**RE: UHOPA-20-012 and ZAC20-016
1107 Main Street West, Hamilton (Ward) 1
Detrimental Impact on Tree Management Plan and Pedestrian Safety
As a Result of Applicant reducing required setback by 3 metres**

Garbage Truck—

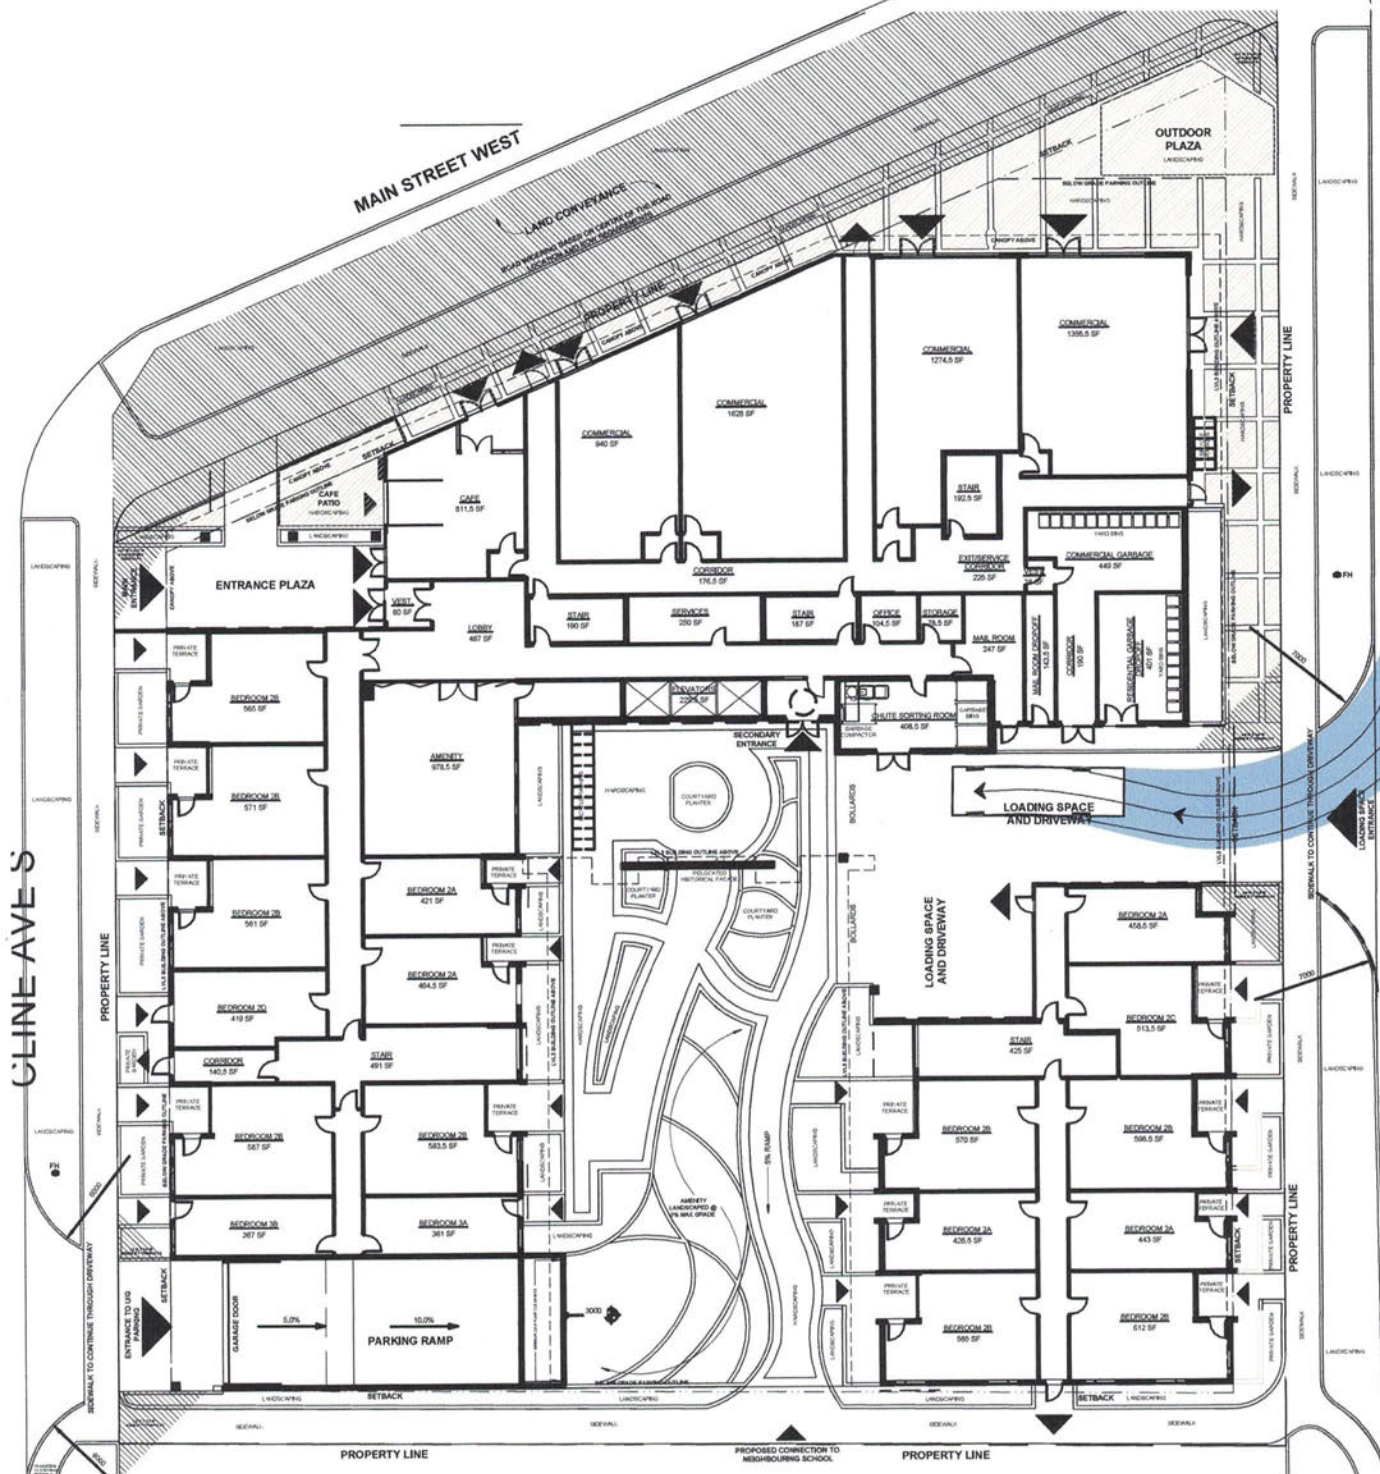
Of particular concern is the Garbage Truck Circulation Review for a Garbage Truck entering the driveway access on Dow Avenue and then turning around within the proposed development and then exiting onto Dow Avenue. (see below)

Looking at the Applicant's Garbage Truck Circulation Review it appears that a Garbage Truck is required to complete a 7-point turn in an extremely narrow Loading Space before the vehicle is able to drive out of the building and onto Dow Avenue. It is my opinion that an experienced garbage truck driver would be able to successfully complete this turn around manoeuvre, but that a less skillful delivery driver, or an individual who is renting a truck for unloading or pickup, would not be prepared to negotiate a 7-point turn, and would elect to back out in reverse from the driveway and reverse back across the sidewalk onto Dow Avenue, or even back into the loading space driveway from Dow Avenue. Both options are extremely dangerous for pedestrian safety.

To compound the matter, if another vehicle was to be parked or idling within the loading space, there may not even be an opportunity to negotiate the 7-point turn, and accordingly any truck driver, or van or delivery truck driver, would have no other alternative than to back the vehicle out of the loading space in reverse onto Dow Avenue.
